# RENESAS TECHNICAL UPDATE

Product Category	MPU/MCU		Document No.	TN-SY*-A0042A/E	Rev.	1.00
Title	Errata for User's Manual regarding the IIC		Information Category	Technical Notification		
Applicable Product	Renesas Synergy™ S1JA MCU Group	Lot No.	Reference Document	S1JA Microcontroller Group User's Manual Rev.1.30		
		All

The specified Renesas Synergy S1JA User's Manual has incorrect statements about the IIC.

## Page 723 of 1281

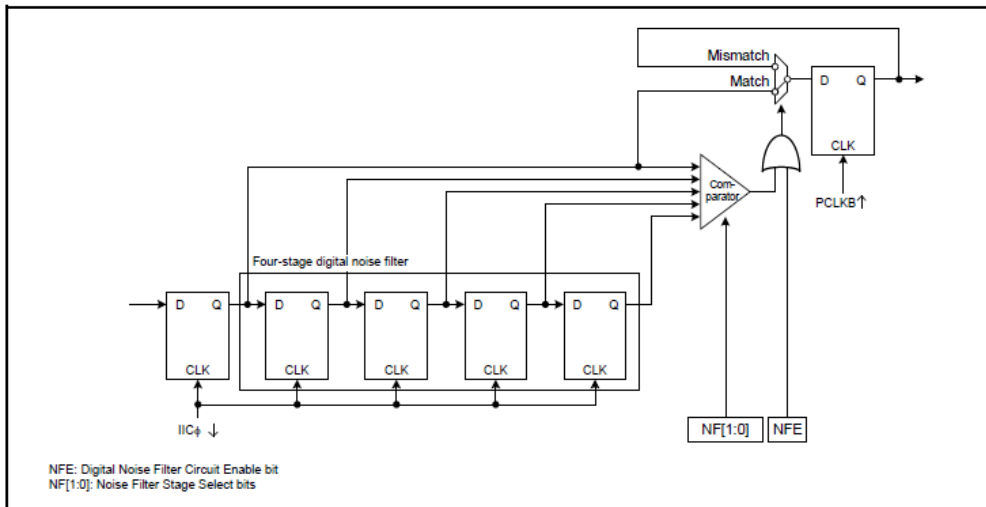
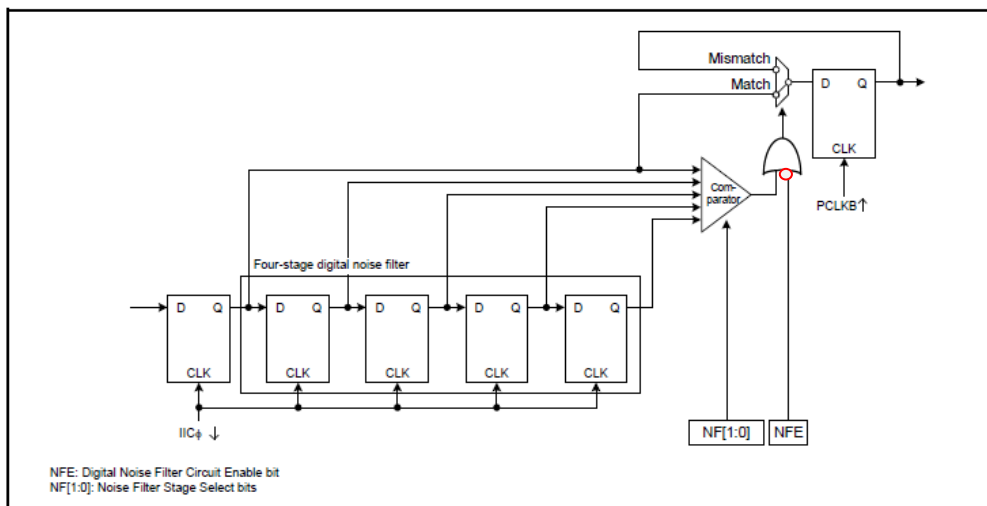
Incorrect Figure

Correct Figure

Incorrect Figure

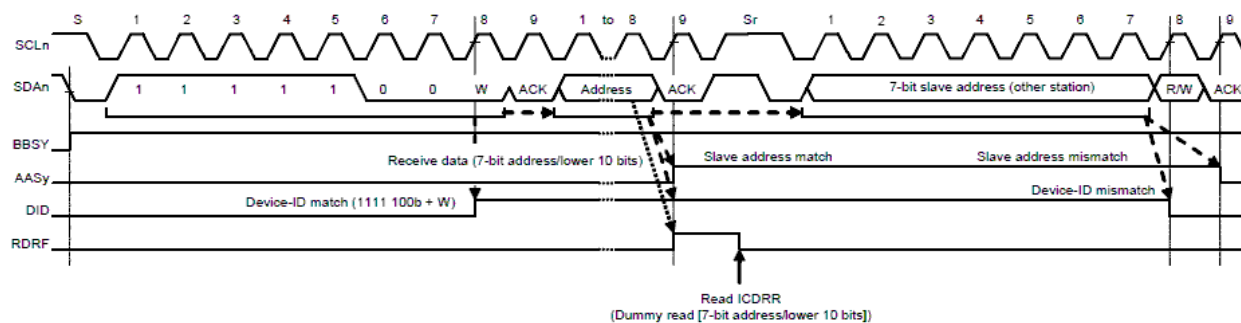
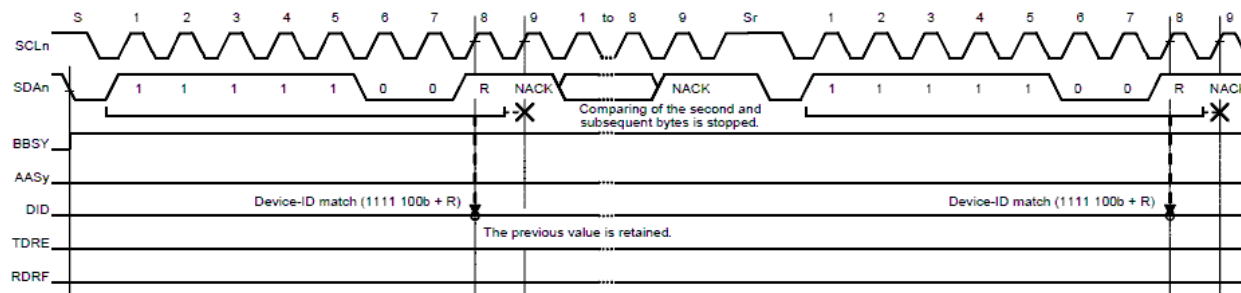
Device-ID reception

When address received after a restart condition is detected does not match the device-ID

When address before the device-ID + R does not match the slave address

Correct Figure

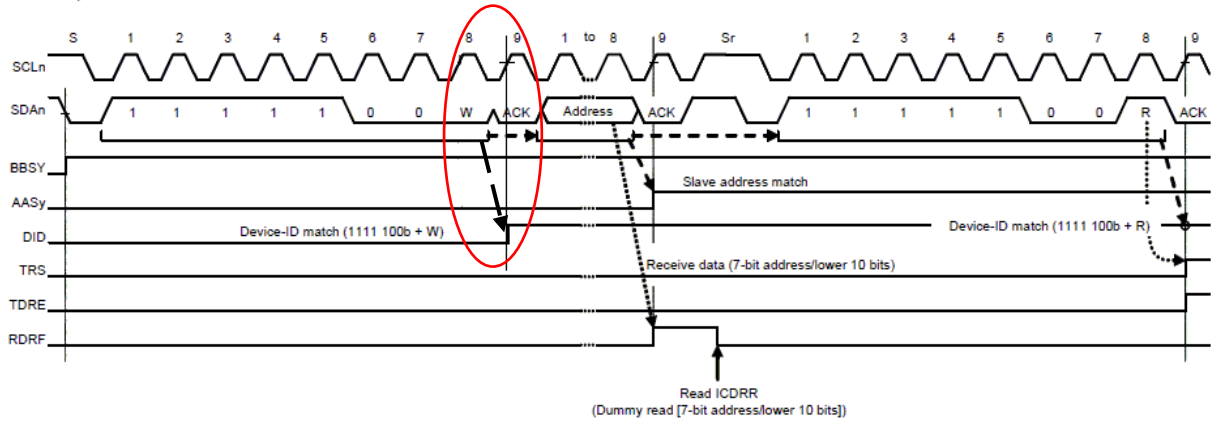
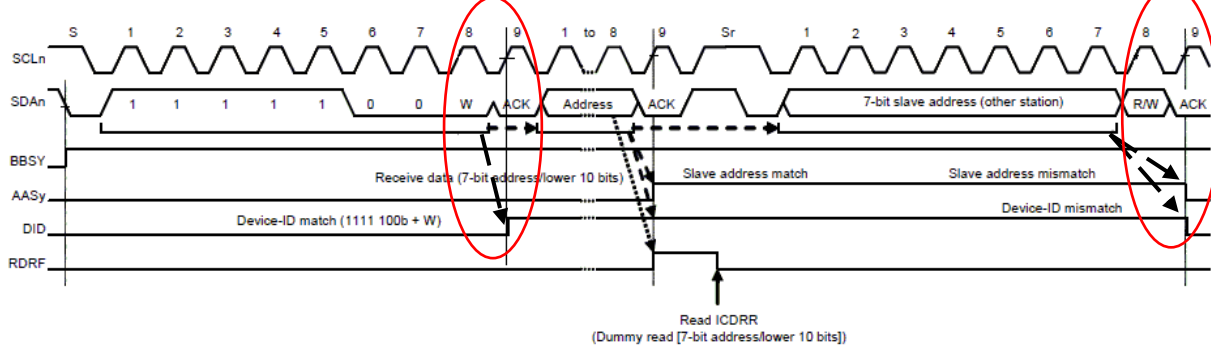
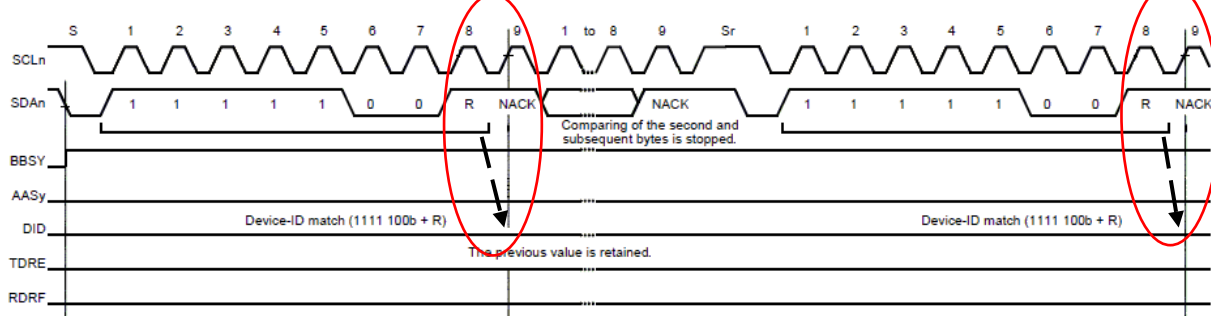
Device-ID reception

When address received after a restart condition is detected does not match the device-ID

When address before the device-ID + R does not match the slave address

Page 764 of 1281

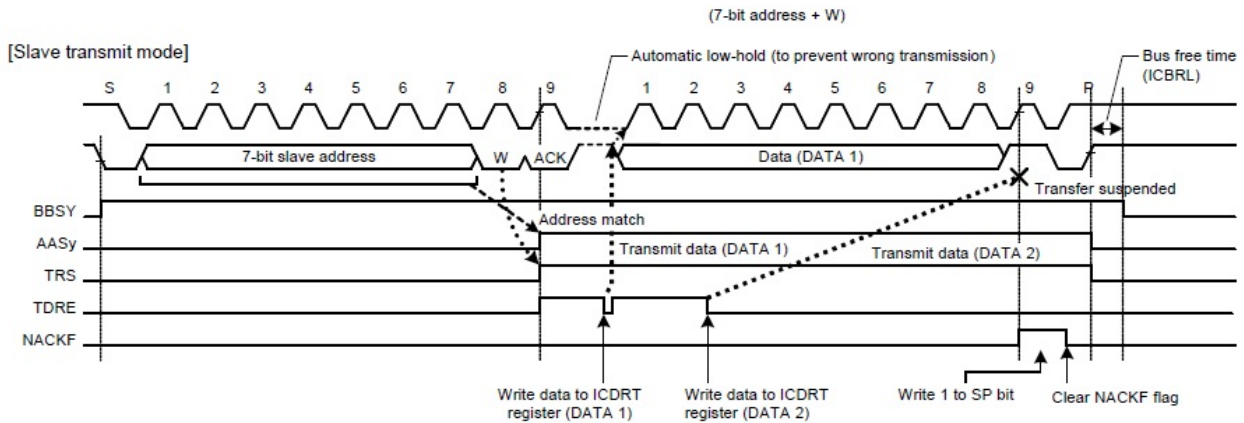
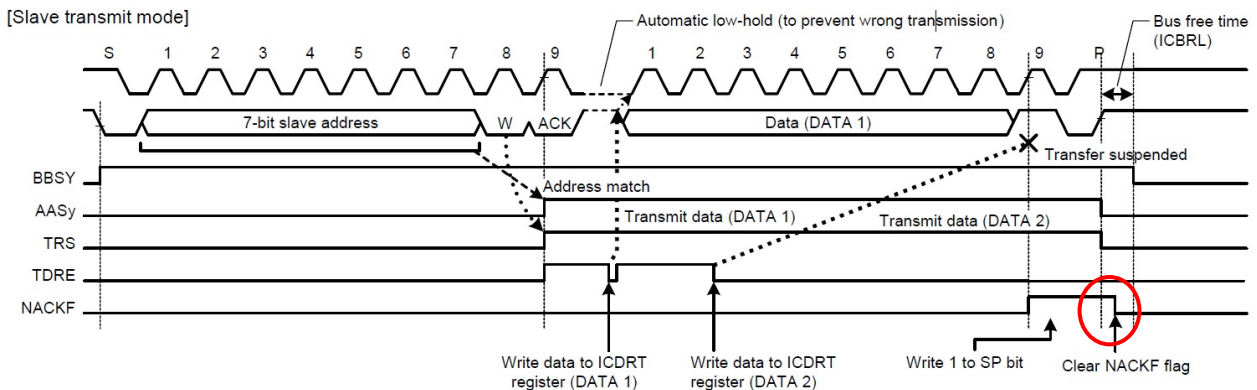
Incorrect Figure

Correct Figure

Page 773 of 1281

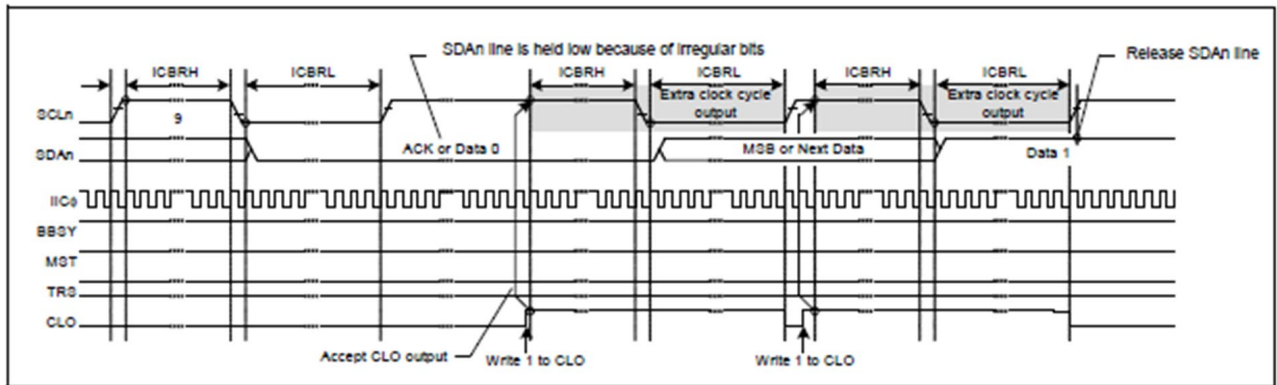
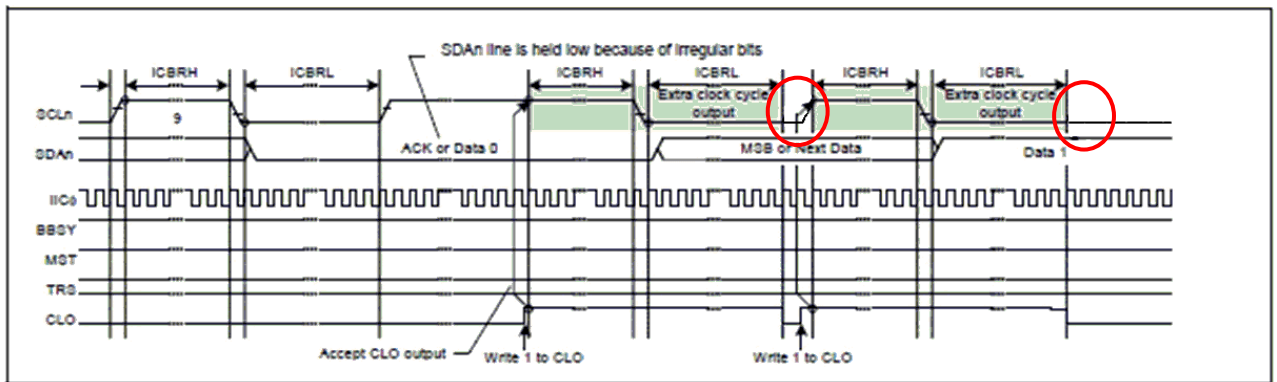
Incorrect Figure

Correct Figure
